**NOTICE OF DECISION TO CONSENT TO CHANGE TO PROPOSAL DURING
ASSESSMENT**

Valhalla Gas Exploration and Appraisal Program
Assessment No. 2281

Summary of reasons for decision – request to amend a referred proposal under s43A of the *Environmental Protection Act 1986*

Proposal Title: Valhalla Gas Exploration and Appraisal Program

Figure 1 Development Envelope and indicative footprint

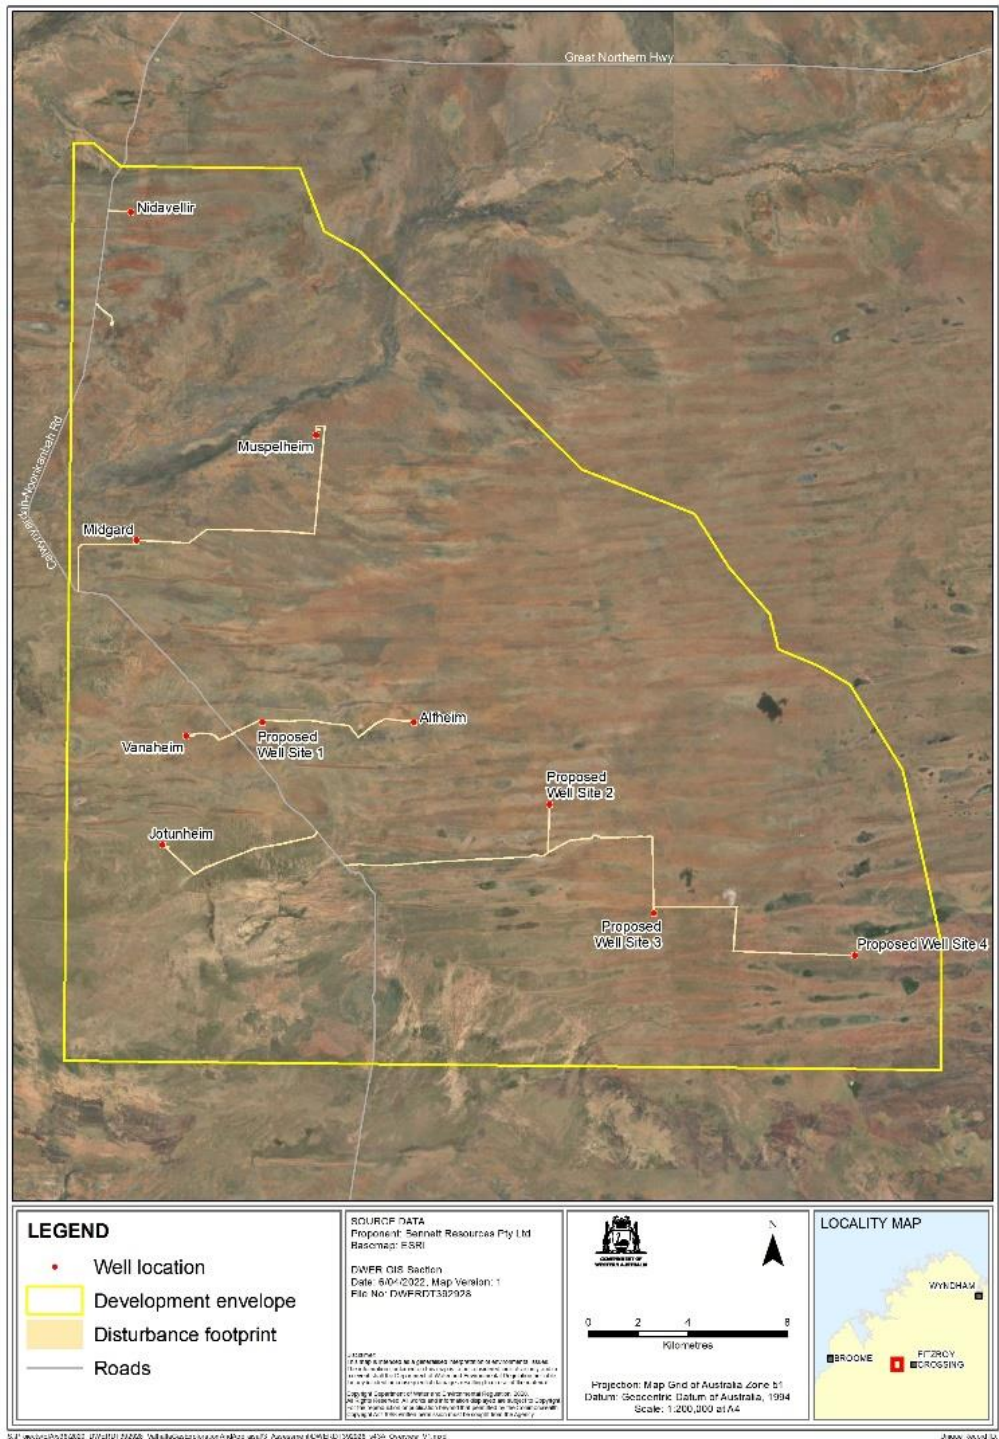
- increase the total area of clearing from 102 to 110 ha
- the total area of the disturbance footprint from 109 to 112 ha
- increase the maximum amount of groundwater abstraction from 40 ML per well to 100 ML per well
- increase the number of hydraulic fracture stimulation (HFS) intervals from 50 to 70 per horizontal well
- use of the term drill site rather than well site for consistency
- inclusion of flare stack to combust gas off the separator as an alternative to Well test flare pit.

Figure 1: Amended indicative disturbance footprint

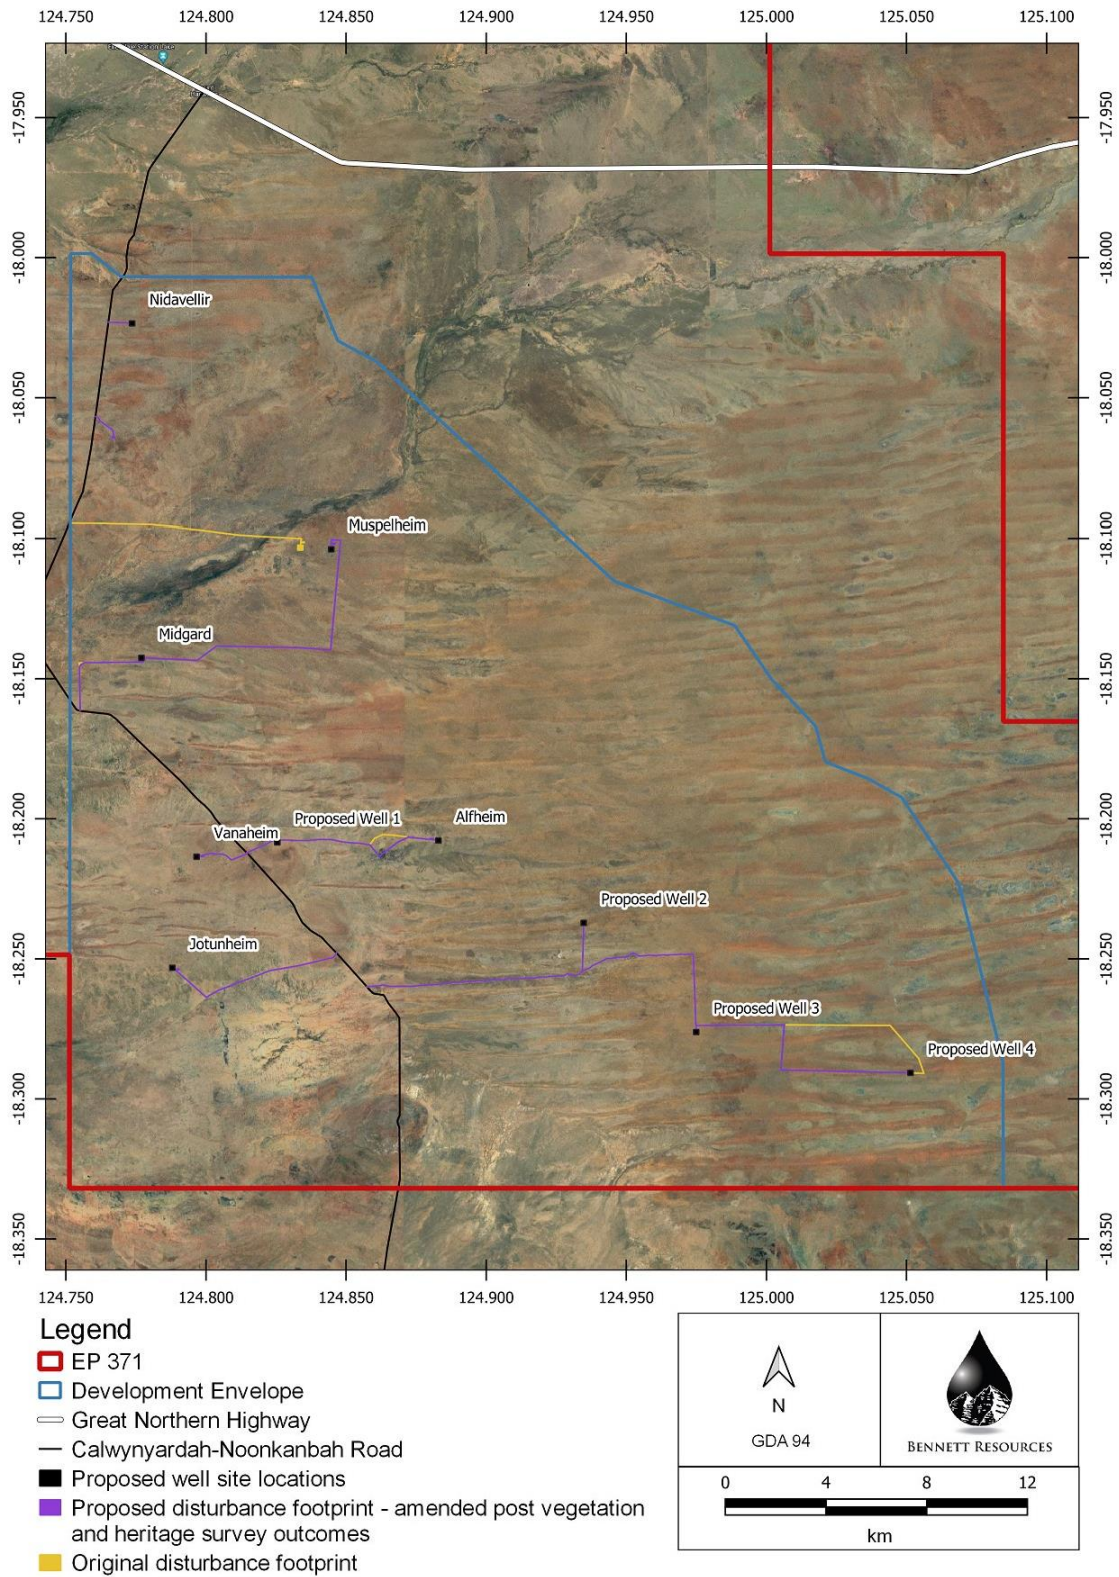
- Increase the total area of clearing from 102 to 110 ha
- increase the total area of the disturbance footprint from 109 to 112 ha
- increase the maximum amount of groundwater abstraction from 40 ML per well to 100 ML per well
- increase the number of hydraulic fracture stimulation (HFS) intervals from 50 to 70 per horizontal well
- inclusion of flare stack to combust gas off the separator as an alternative to well test flare pit
- use of the term drill site rather than well site for consistency.

Amendment sought	Changes to environmental impacts
<p>Increase the total area of clearing from 102 to 110 ha. The change reflects the avoidance and mitigation measures the proponent is committing to avoid several sensitive areas</p>	<p>The revised indicative disturbance footprint is shown in Figure 1 and represents a 6.8 percent increase in native vegetation clearing to align tracks to avoid sensitive sites.</p> <p>The area of increased clearing of native vegetation is pindan and spinifex vegetation types which is regionally common.</p> <p>The change would increase avoidance of known listed flora species and vegetation features (large trees, riparian vegetation).</p> <p>The disturbance area has been redesigned to avoid crossing the creek and no works will occur within 100 m each side of the Mt Hardman Creek.</p> <p>Redesign of the track also decreases effect on heritage values as it avoids a heritage site (bore) and associated structures (dam).</p> <p>The impacts of the changes will be considered in the assessment.</p>

Amendments to proposal as described above and shown in Figure 1 of Attachment 1 are approved.

Figure 3 BNR Phase 2 indicative well design

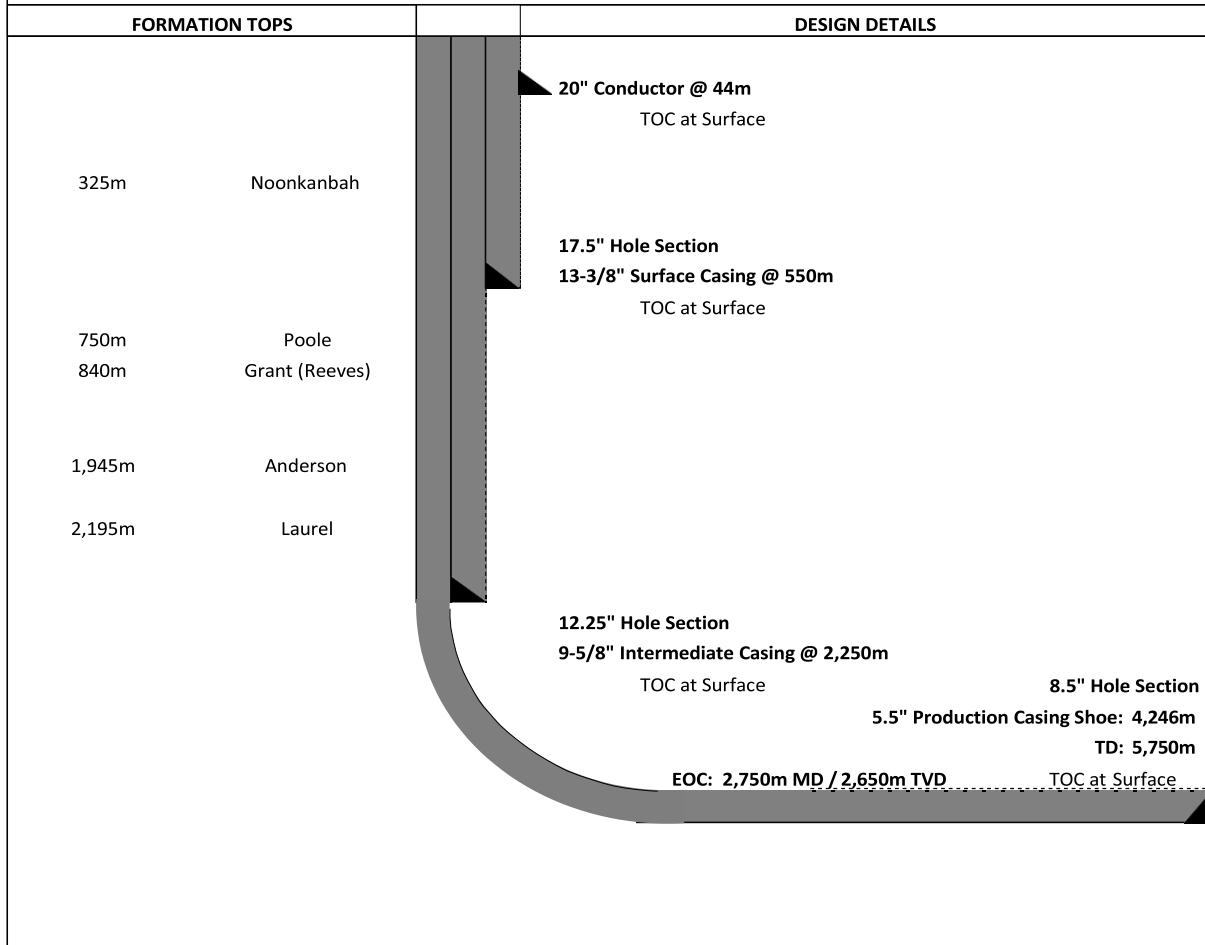
<p>Change in numbers of HFS intervals for Phase 2 well design from 50 to 70</p>	<p>The main impact of this change is the duration of the drilling program and air, light and noise emissions. The environmental risks and risk levels are unlikely to change significantly given the remote location and proximity to receptors sensitive to these emissions. The duration of the activity is still generally consistent with what has been described in previous documentation due to a conservative approach to the time required for the drilling program.</p> <p>The impacts of the changes will be considered in the assessment.</p>
<p>increase in groundwater extraction per well from 40 to 100 ML per well</p>	<p>Refinement of well design, specifically for Phase II wells, has led to an updated requirement of up to 100 ML of groundwater abstraction. This could result in a temporary increase in groundwater drawdown.</p> <p>Groundwater level recovery is still expected to be within 0.2 m of the static water level within hours of the cessation of pumping, and to fully recover within weeks.</p> <p>There are limited groundwater demands within 1 km of well sites and the area in general so there would be limited risks of cumulative impacts.</p> <p>The impacts of the changes will be considered in the assessment.</p>
